PUBLIC INTEREST REVIEW FOR GROUND WATER APPLICATIONS

SUBJECT: Application G- 17635 Supersedes review of _____
Date of Review(s)

A. GENERAL INFORMATION: Applicant's Name: Queen Resources, LLC County: Malheur

Application G-17635, Queen Resources, LLC

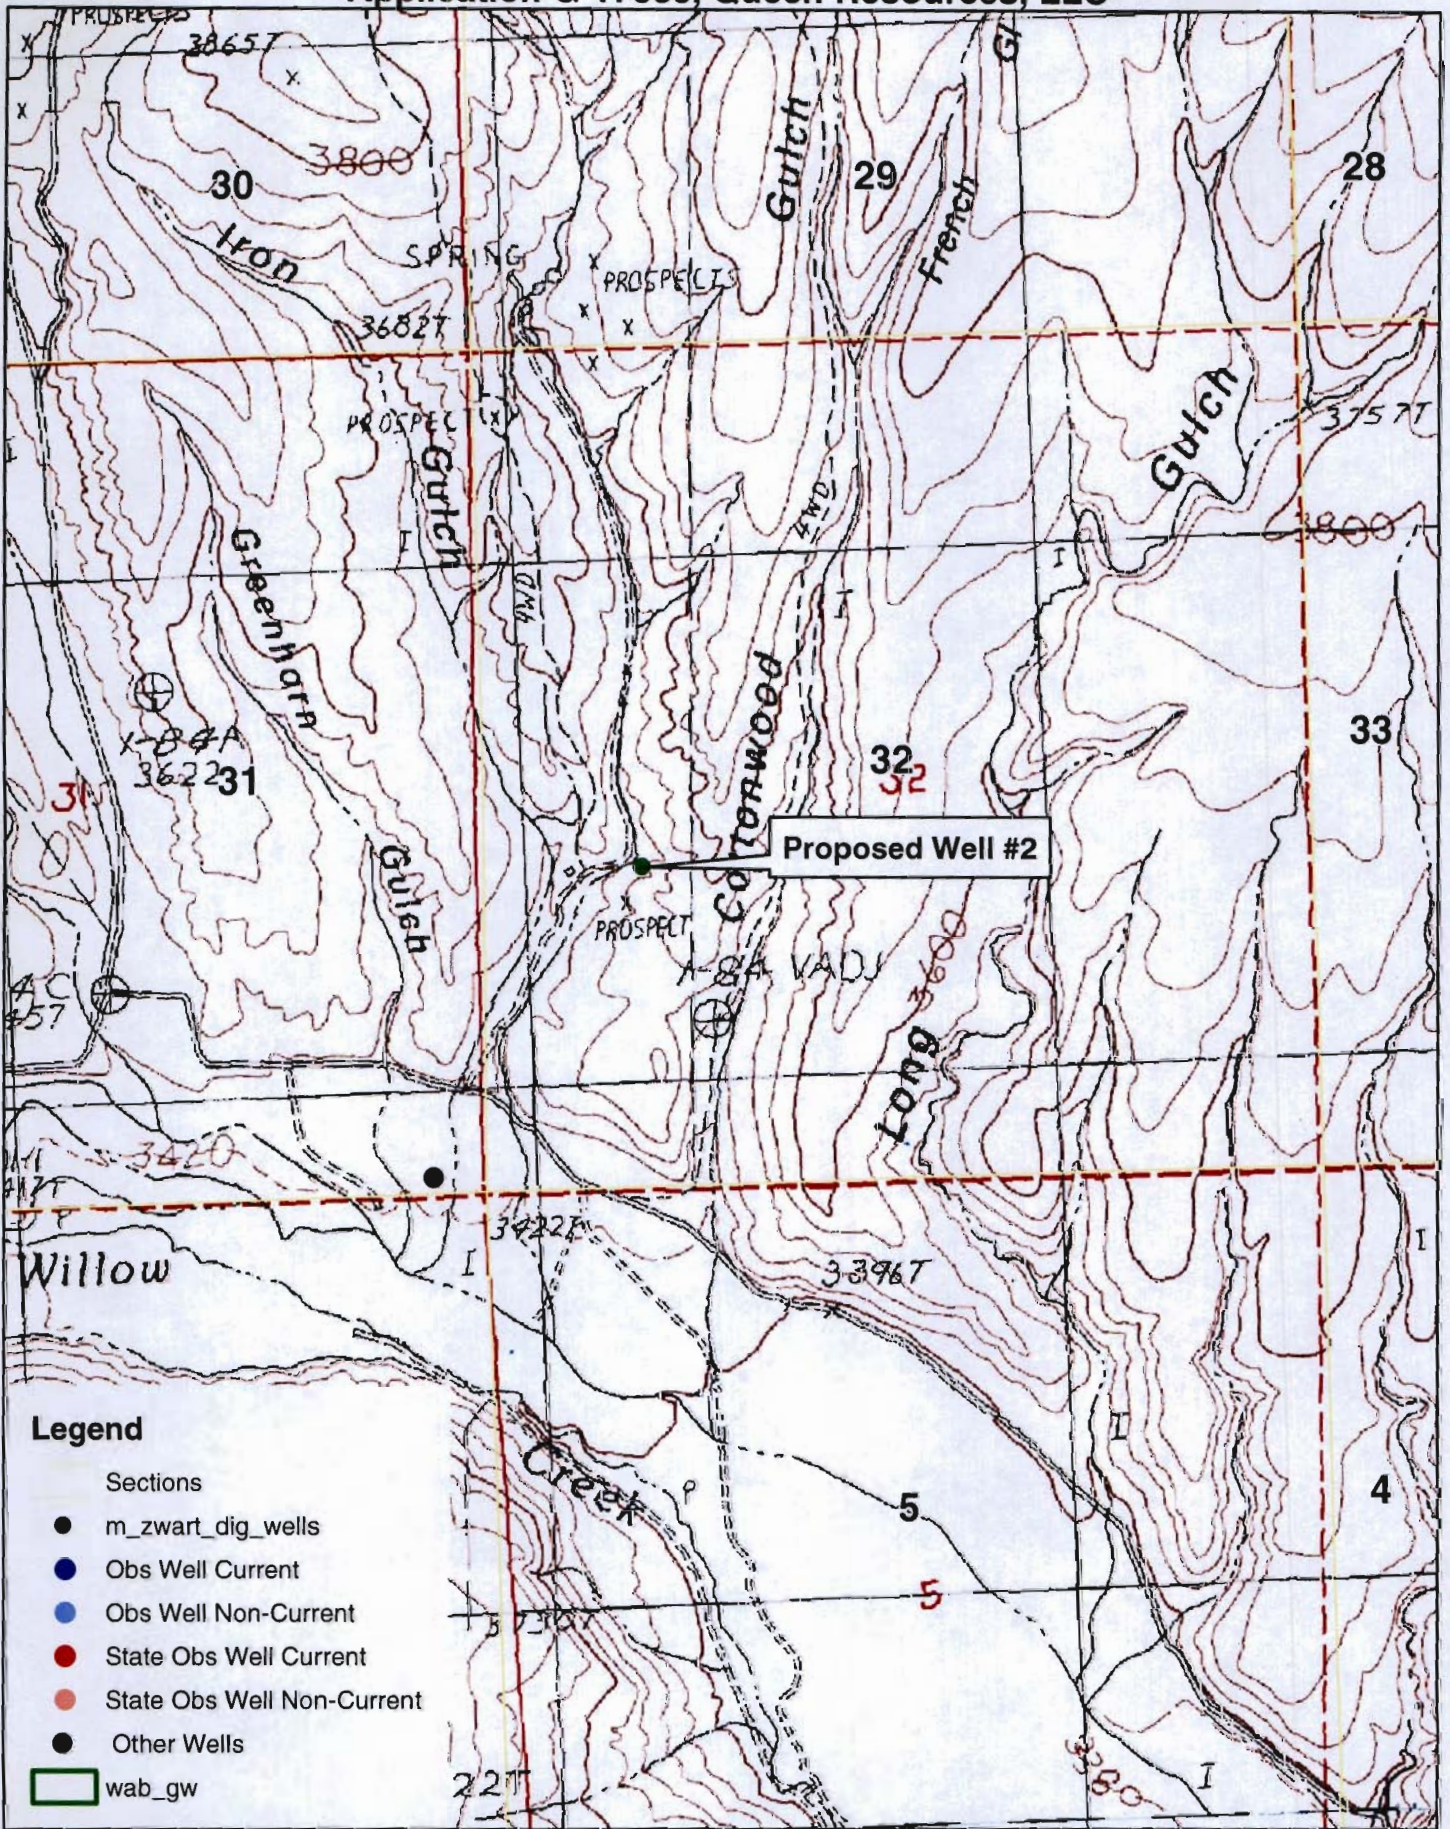
A4. **Comments: Well construction is proposed and is based closely on MALH 005 located about 2350 feet to the southwest.**

B3. **Ground water availability remarks:** The application includes documentation that consumptive use will be minimal. The area is rather remote and there is limited development of groundwater except for nearby permit G-13389, which authorizes one well (MALH 005) for similar uses.

Basis for aquifer confinement evaluation: Nearby well MALH 005 is flowing artesian.

Basis for aquifer hydraulic connection evaluation: Based on the proposed well construction and local geology, the aquifer is not likely to be hydraulically connected to the creek within one mile.
